APPLICATION PZC 2016-11 #1

STAFF REPORT

To: Chairperson Stratman and Members of the Planning & Zoning Commission
From: Mary Meyer, Zoning Inspector
CC: Michael J. Earl, Director of Community Services
Sam Hubbard, Acting Director of Building & Zoning
Date: January 15, 2016
Re: **PZC 2016-11 #1 Zoning Application for Sparrow Ridge Plaza, 1075-1077 S. Rand Rd.**

FRONT FACADE

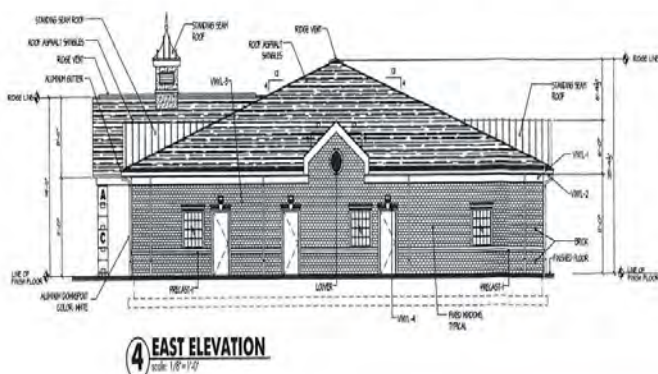
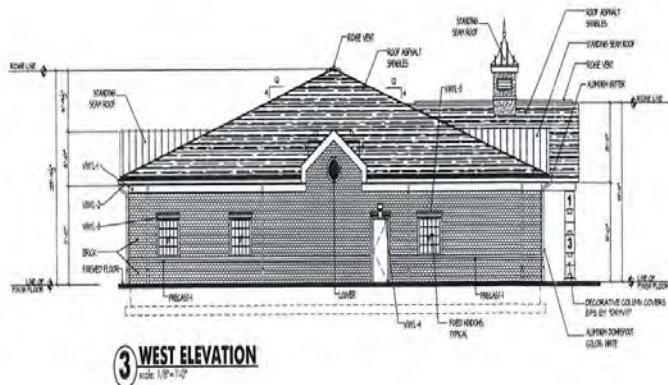
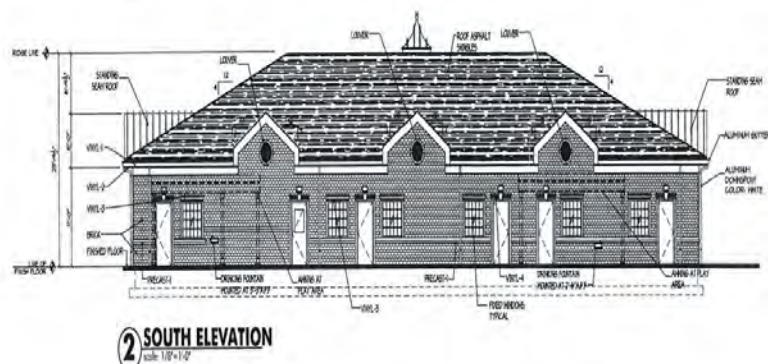
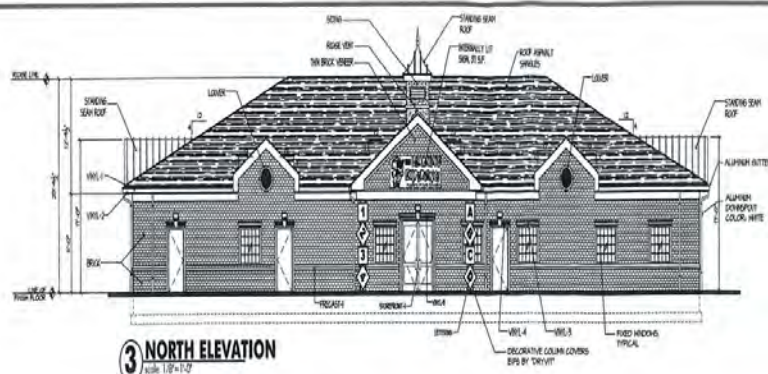
Staff Response: Standard not yet met. The proposed buildings include the gas station as brick with stone accents and EIFS band, the retail building is brick with stone accents and EIFS band, although side elevations are not indicated. No elevations are shown for the daycare building, except a partial front elevation with the primary color sign columns, and what appears to be siding with a brick base. Elevations are required for all buildings, including colors and materials.

Staff Response: Standard not yet met. Need daycare building elevations as well as side elevations of retail building.
